ADA Compliance Program

Clark County Facilities Transition Plan Mabry Corrections Facility

Date of Survey: October 31, 2006

Fig. 604.5.1
 Side Wall Grab Bar for Water Closet

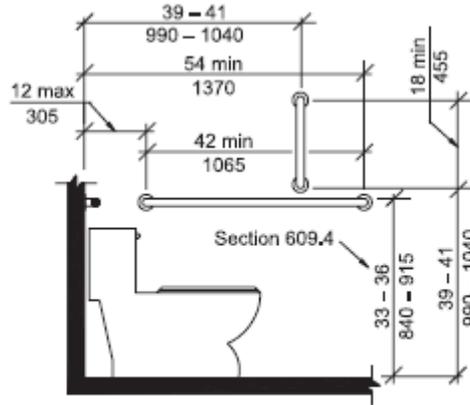
Item # 7
 Issue: Floor Maneuvering Space
 Issue: Vertical Grab Bar
 Location: North Portable Public Access Restroom
 Code: ANSI 604.5.1 – Vertical Grab Bar
